# MARCO POLO - 101 W 33RD STREET

Date	Description
05.19.2022	Progress Set

1  
A102 FLOOR PLAN - 2ND FLOOR  
1/4" = 1'-0"

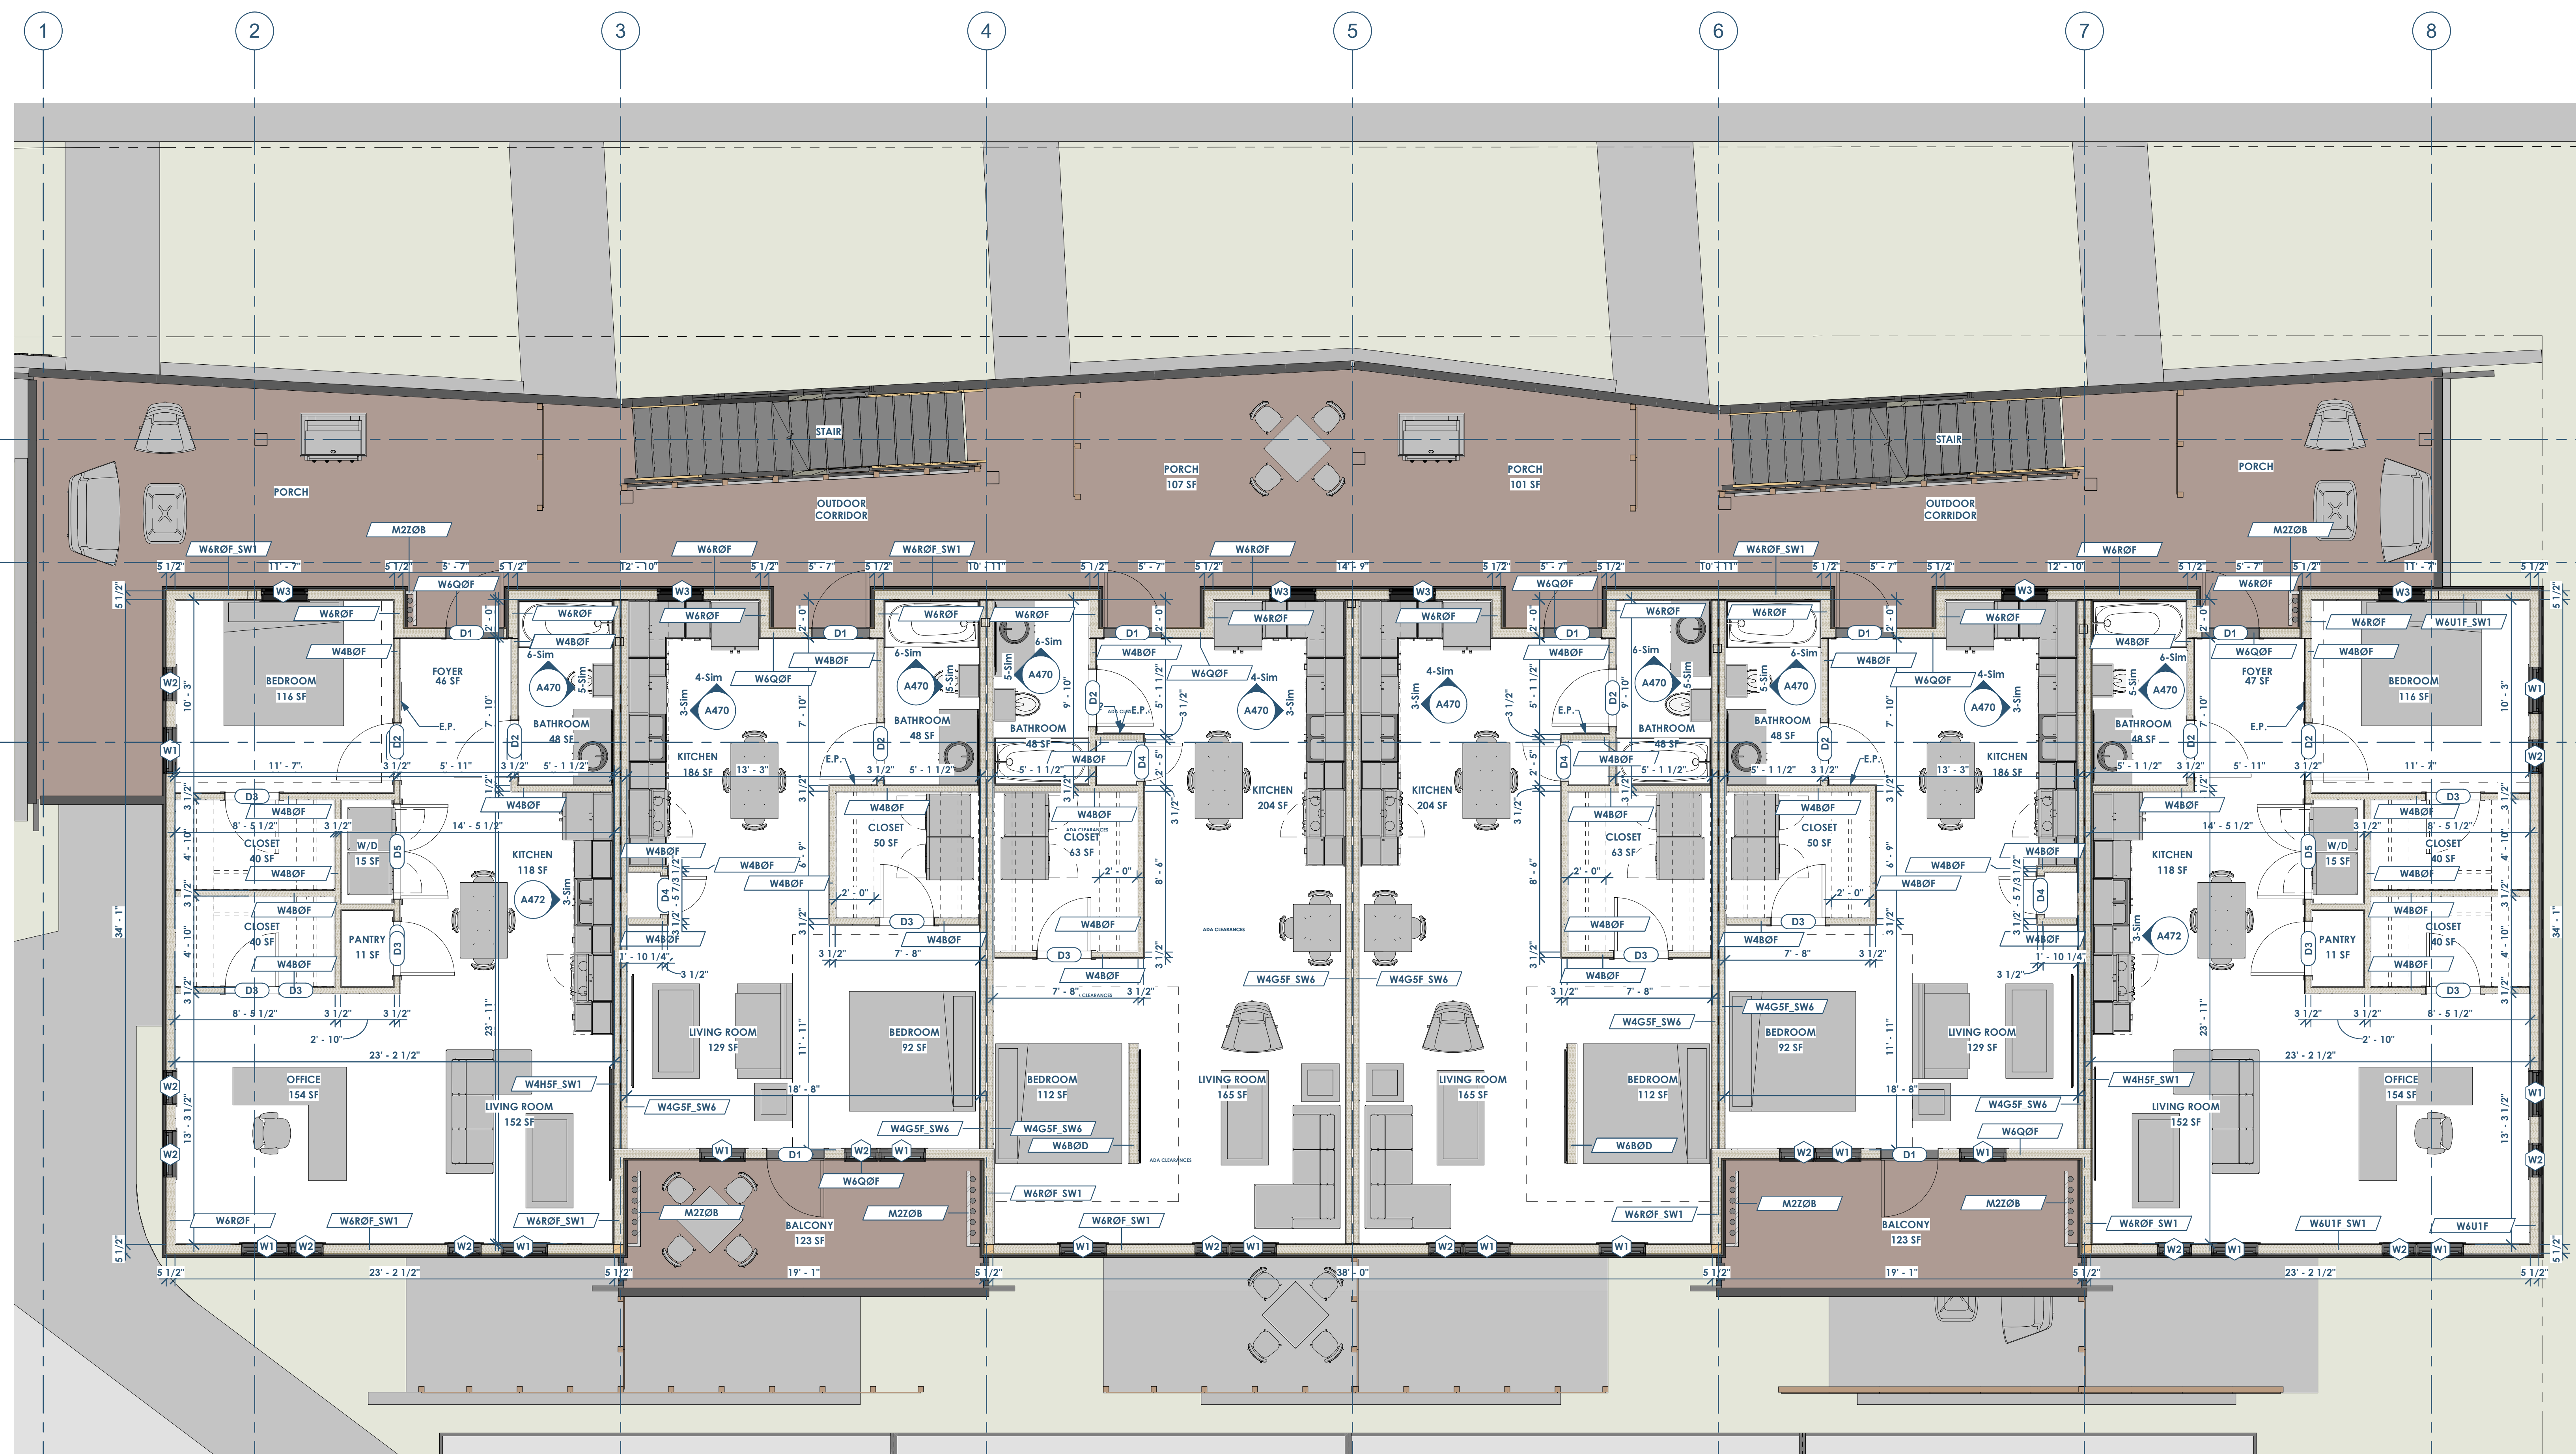
REF. COMMENTS A101

1 A103 FLOOR PLAN - 3RD FLOOR  
1/4" = 1'-0"

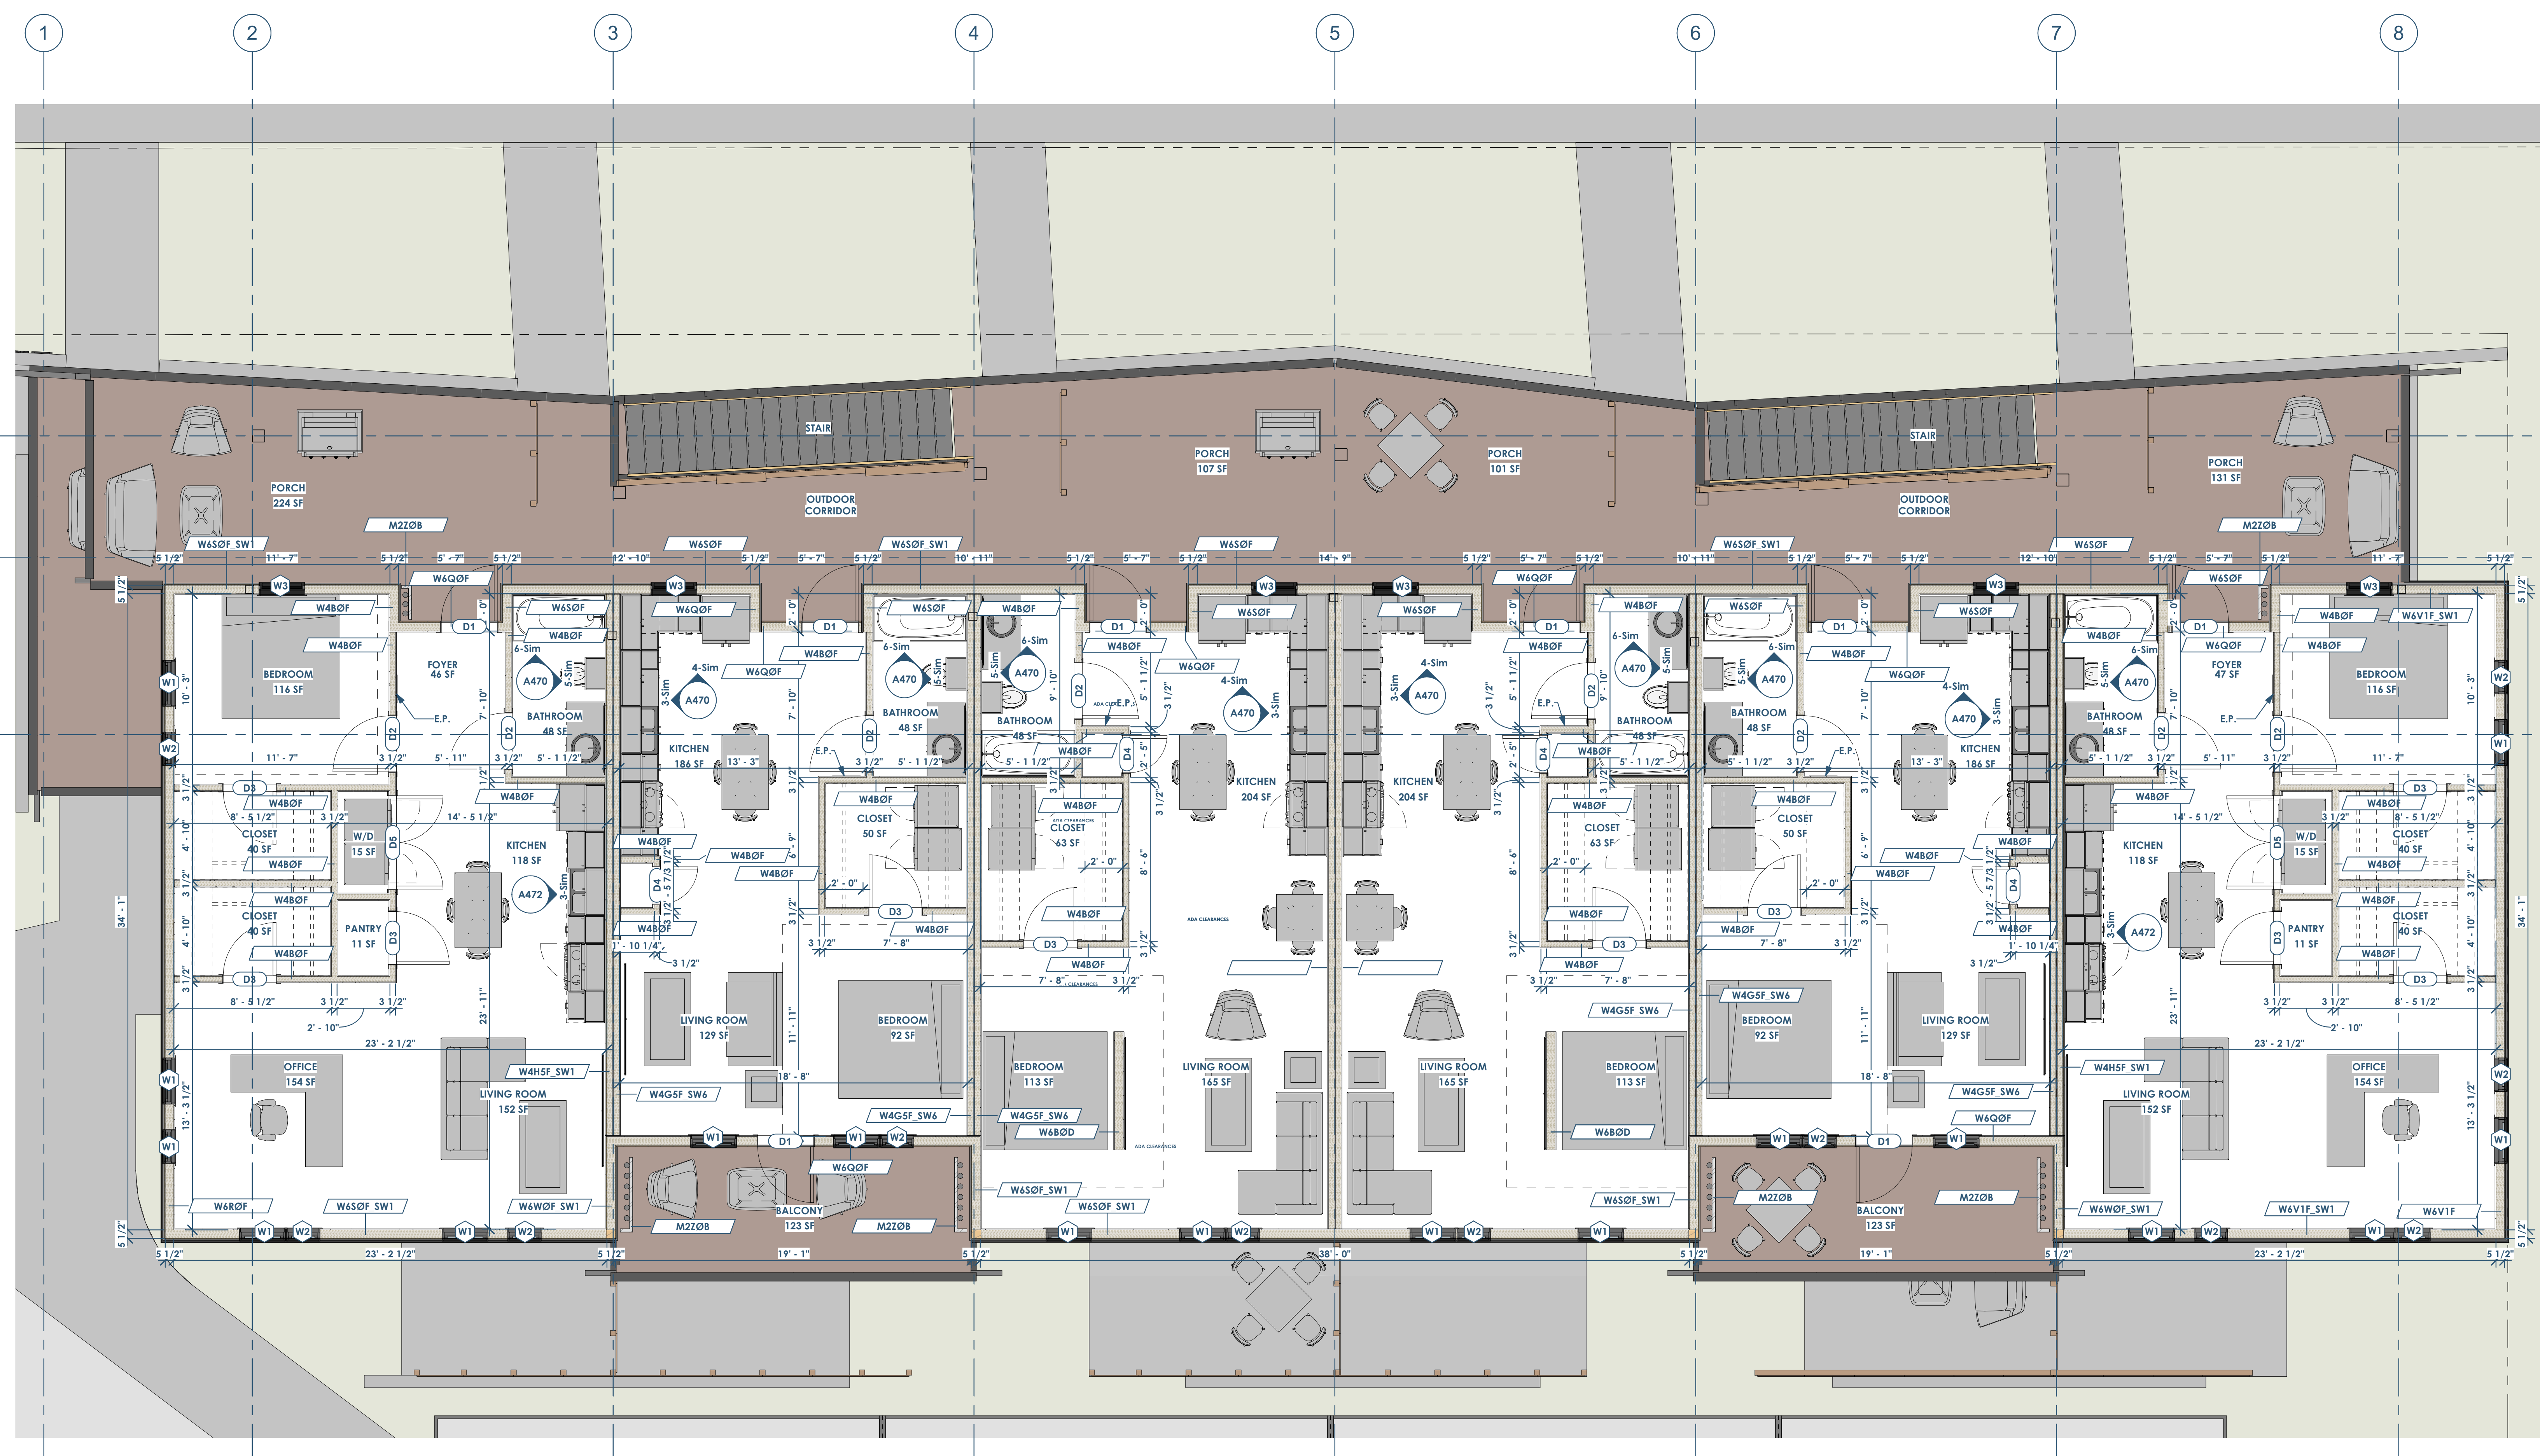
REF. COMMENTS A101
